Special Bulletin

SP19-09

JUMPER ON A175

Prevost vehicles

Figure 1

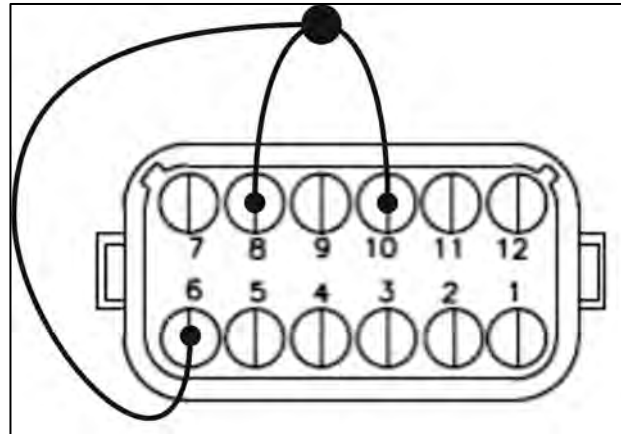
1. Crimp pin terminals 562286 on both ends of an 18AWG red wire, about 3 inches long.
2. Crimp one pin terminal 562286 to the end of another short 18AWG red wire.
3. Splice the bare end of the wire to the middle of the first wire.
4. Seal the splice with heat shrink.
5. Insert terminals in cavities 8, 9 and 6 of connector housing 563613 as shown on Figure 1.
6. Insert secondary lock 563654.

Figure 2

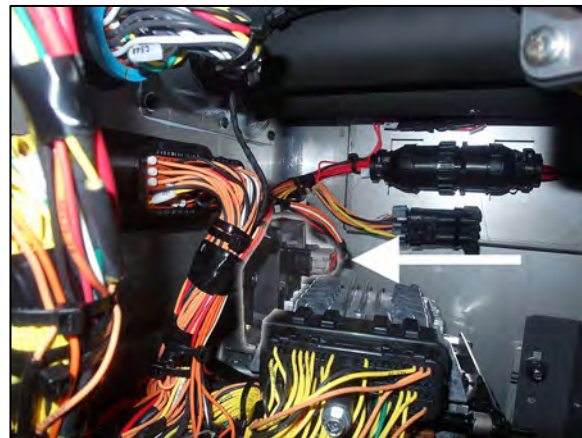
7. In the Main power compartment (RJB), locate the boost regulator. You will find it above the TCM.
8. Unplug the connector (A175).

9. Connect the newly created jumper connector to the harness, connector A175.
